Application for DCO by FOSSE GREEN
Summary of Representation by Anne Heard Interested Party reference F88728215
Deadline 1

Application for DCO by FOSSE GREEN
Representation by Interested Party reference F88728215
Deadline 1

Fig 2 Circular walk from Church Bridge Bassingham

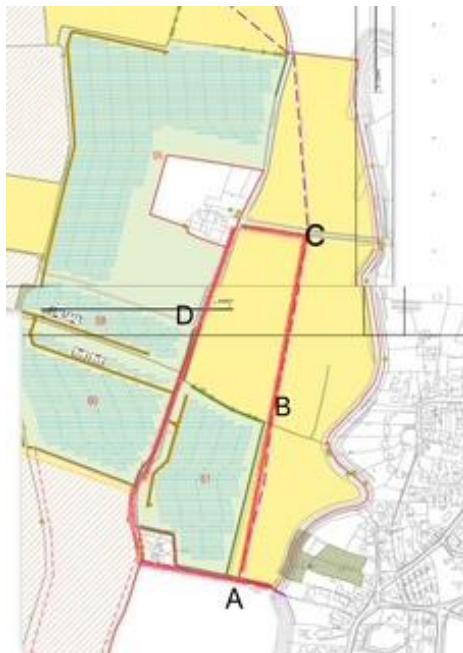
5.1.3 Part of the Bassingham and Villages Stepping Out walk includes a network of ProW to the west of Bassingham (which form a circular route from Church Bridge including Clay Lane). It is a well used network of footpaths, for example I travelled along this route on a sunny Sunday between 12.00 and 12.30 on 7 September 2025 when I met 2 cyclists and 8 walkers. The route of the circular walk is shown on the plan below:-

Fig 3 Route of the Thorpe on the Hill Stepping out Walk

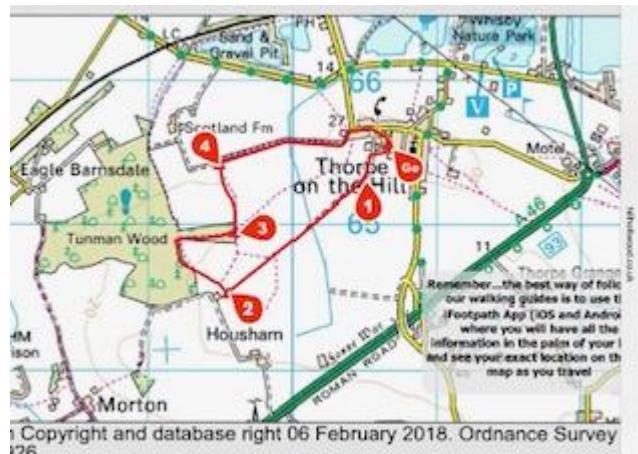
5.1.4 Also on a circular route is the Thorpe on the Hill Stepping Out Walk of 4.5 km “through woodland and open countryside with lots of hedgerow birds and lovely views back to the village”. A suggested short cut is from point 3 back towards the village.

Fig 4 Route of Thorpe on the Hill Stepping Out walk superimposed on noise contour plan of distributed BESS

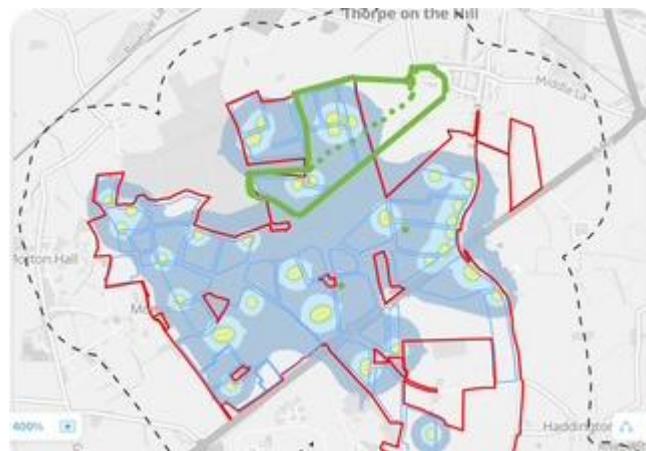
5.1.6 The route of the circular walk shown with a green line (the suggested short cut is shown with a dotted green line) has been superimposed on the Applicant’s noise contour plan with a distributed BESS (Fig 11.3 (AS-063)) illustrating that anyone walking along this route during the operational period of the proposed development will be subjected to noise over a substantial part of the route:-

Fig 1 Anglian River Basin District River Basin Management plan produced by the Environment Agency and updated 2022

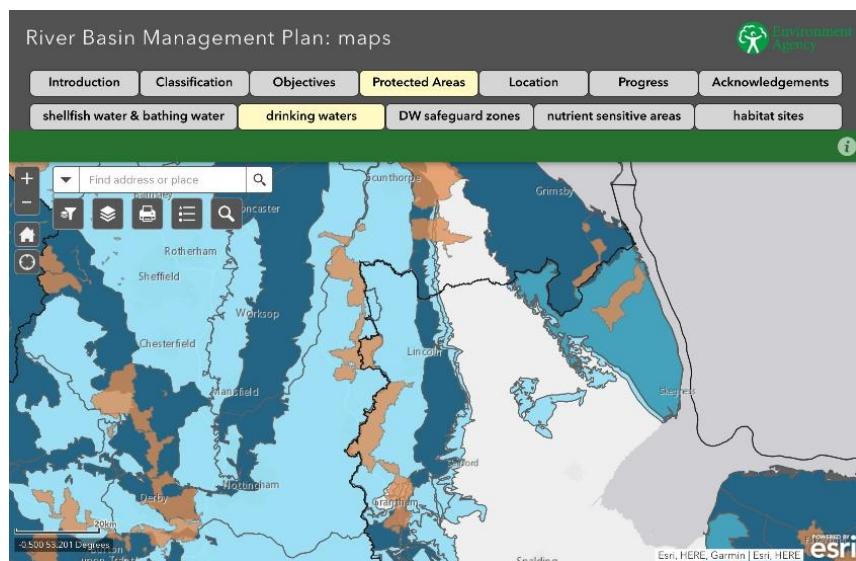
8.1.1 Paragraph 9.5.74 of Chapter 9 Water Environment (APP-034) states that the area from Bassingham to the A46 is a Drinking Water Protected area (Surface Water). The Applicant has failed to mention that the remainder of the order limits is within a Drinking Water Protected area (Groundwater). Both types of protected areas are identified as used now or may be used in future, for abstracting water for drinking, cooking, preparing food or in food production businesses. These areas are shown on the Anglian River Basin District River Basin Management plan produced by the Environment Agency and updated 2022. (The River Basin Management Plan is made in accordance with the Water Framework Directive which originates from the European Union but which has been incorporated into English Law by the Water Environment (Water Framework Directive) Regulations 2017). Paragraph 7 of the current condition and environmental objectives chapter of the plan states that hazardous substances must be prevented from entry into groundwater.
